**TWENTY-SECOND MEETING OF THE  
ASIA/PACIFIC AIR NAVIGATION PLANNING AND  
IMPLEMENTATION REGIONAL GROUP (APANPIRG/22)**

**Agenda Item 3:  
3.1**
**Performance Framework for Regional Air Navigation Planning  
and Implementation- AOP**
**AMENDMENT PROPOSALS TO ANNEX 14, VOLUME II**

- A — Proposed amendment to Annex 14, Volume II
- B — Response Form

**Figure 5-8 Helicopter stand designed for hover-turning markings**

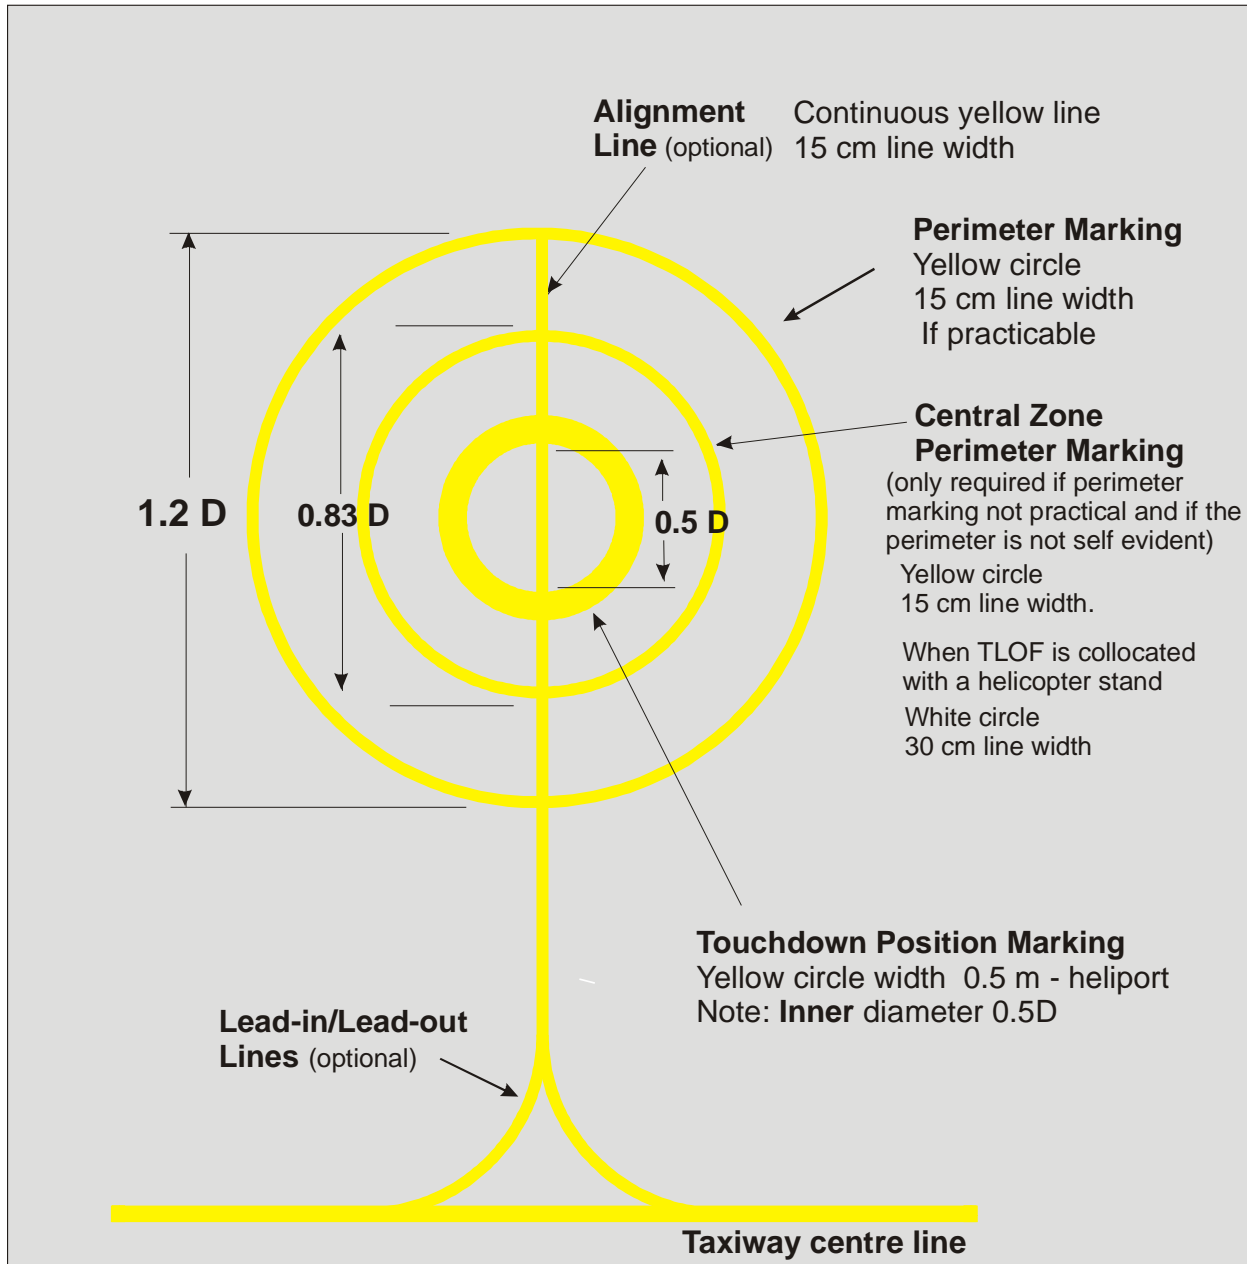
*Editorial Note.— New Figure 5-8:*

5.2.17.6 Alignment lines and lead-in/lead-out lines shall be located as shown in Figure 5-8.

**Figure 5-9 Flight path alignment guidance markings and lights**

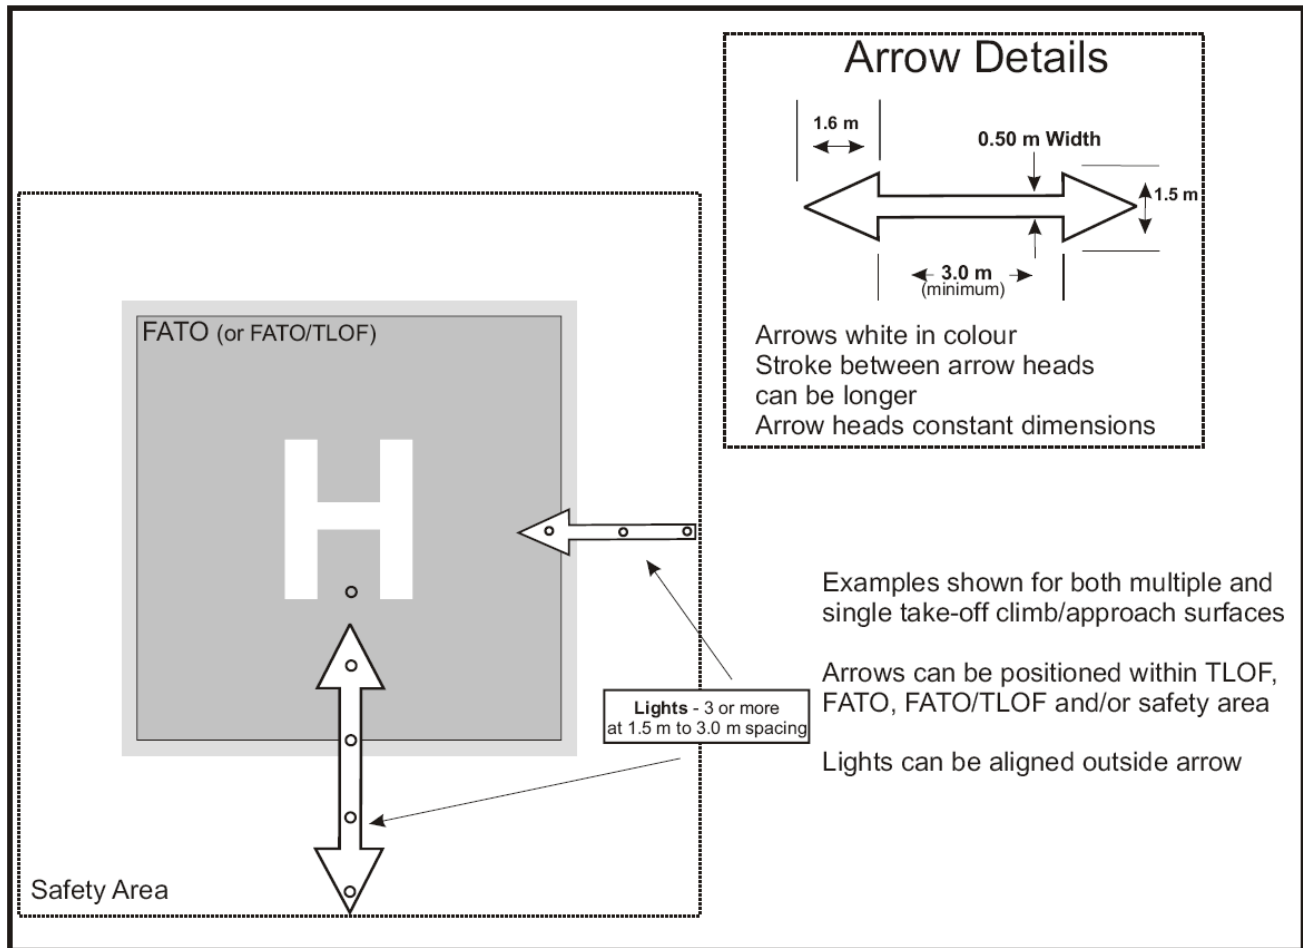
*Editorial Note.*— *New Figure 5-9:*

5.2.18.3 A flight path alignment guidance marking shall consist of one or more arrows marked on the TLOF, FATO or FATO/TLOF and/or safety area surface as shown in Figure 5-9. The stroke of the arrow(s) shall be 50 cm in width and at least 3 m in length. When combined with a flight path alignment guidance lighting system it shall take the form shown in Figure 5-9 which includes scheme for marking 'heads of the arrows' which are constant regardless of stroke length.

5.3.4.4 **Recommendation**—*A flight path alignment guidance lighting system should consist of a row of three or more lights spaced uniformly a total minimum distance of 6 m. Intervals between lights should not be less than 1.5 m and should not exceed 3 m. Where space permits there should be 5 lights. See Figure 5-9.*
